REGIONAL REVIEW NOTIFICATION

ARC REVIEW CODE: R1905281

Name of Proposal: Marietta Boulevard Mixed Use (DRI 2929)

TITLE	
ZONING PLAN	
DATE	04/25/2019
JOB NO.	19010
DWG	2019-04-23_19010+HW1-DRI PLAN
DRAWN	CS
CHECKED	TF
SCALE	1"=30'
SHEET	P - 1
1 OF 1

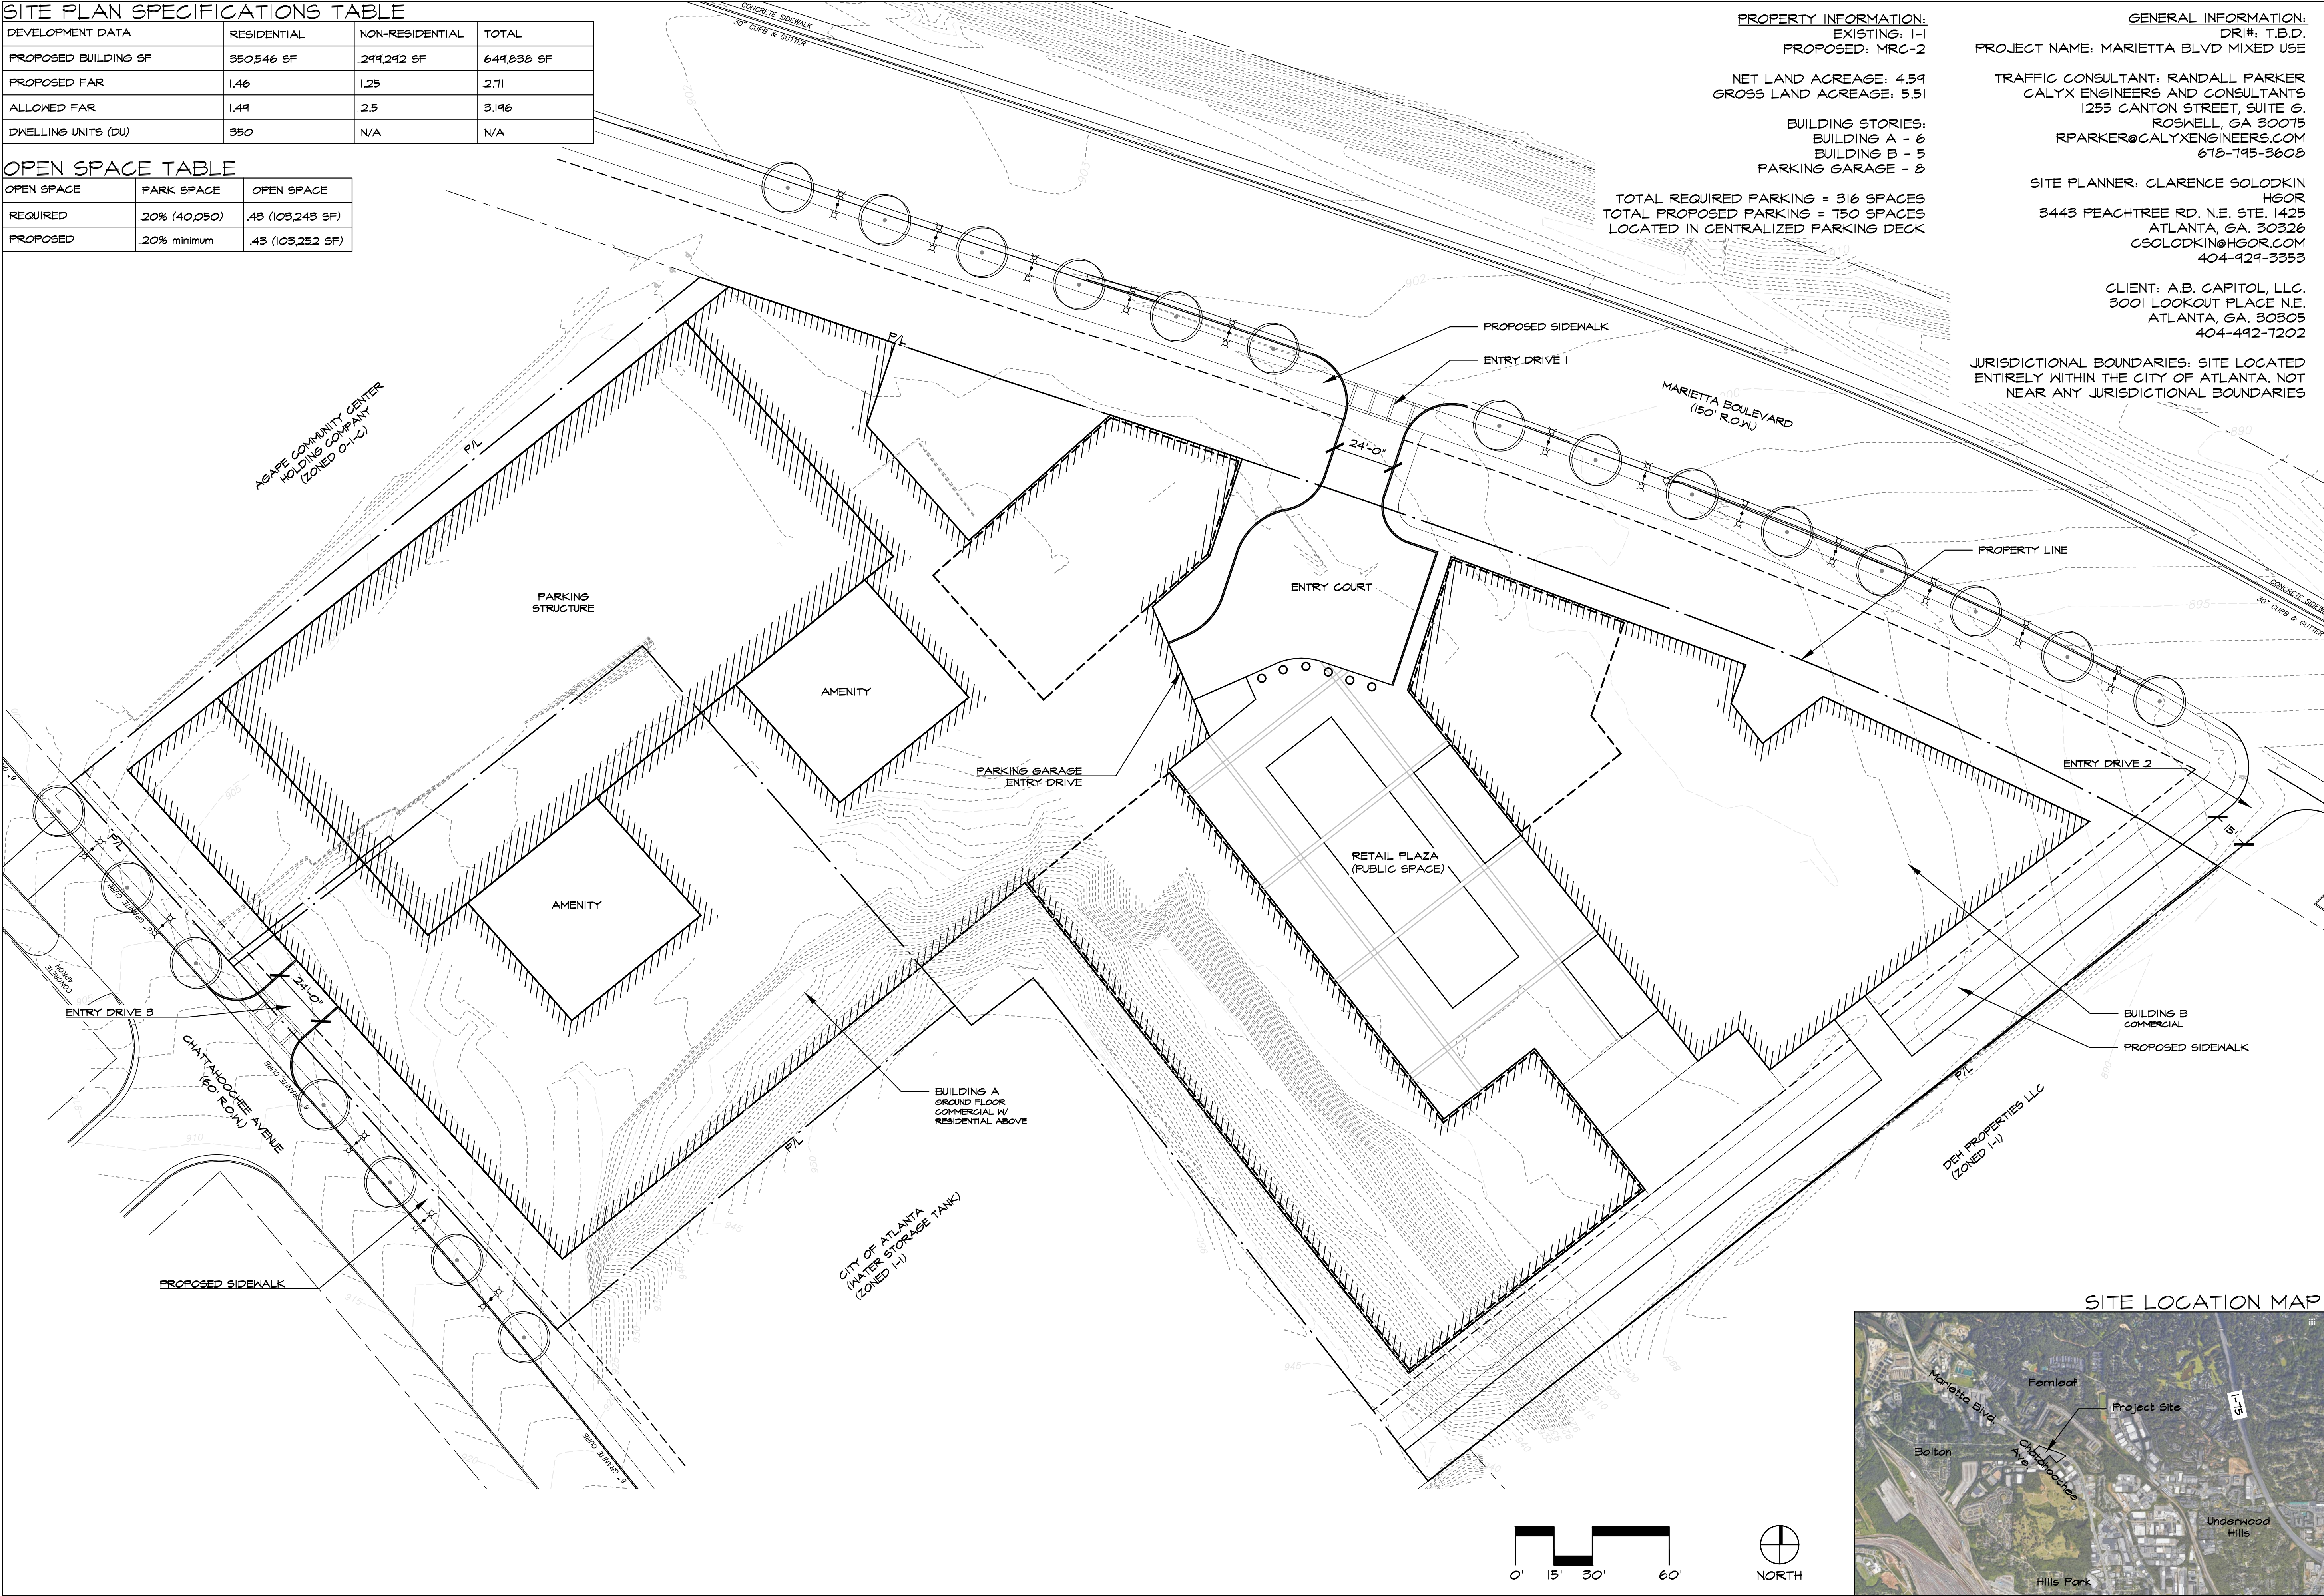
This includes access for bicyclists and pedestrians – including those coming from MARTA bus stops – at the main site driveway (Site Driveway 1) on Marietta Blvd. The submitted site plan does not show a clear connection from the sidewalk fronting Marietta Blvd., through the setback, to the entry court and retail plaza. Provisions for access from all sides also include access westward – to recreational facilities such as the Whetstone Creek Trail and to the Chattahoochee Avenue side of the development in general, as many businesses, including a brewery, are adjacent to the development on this side. For this connection, the site plan shows a parking deck at the rear of Building A (ground floor commercial with residential above) with driveway access from the front and the back of the development. It is not clear if there is general pedestrian access through the parking deck from the rear of the development. ARC recommends that the applicant team work to connect pedestrians from Chattahoochee Ave. through the development, in some way, to reach the retail plaza and Building B on Marietta Blvd. – while of course ensuring secure access for tenants and residents. This could serve as a supplemental or interim access route until such time that the street serving Site Driveway 2 is connected from Marietta Blvd. all the way through to Chattahoochee Ave., adjacent to the City of Atlanta water tower site, which ARC understands to be a desired future goal for the applicant team.
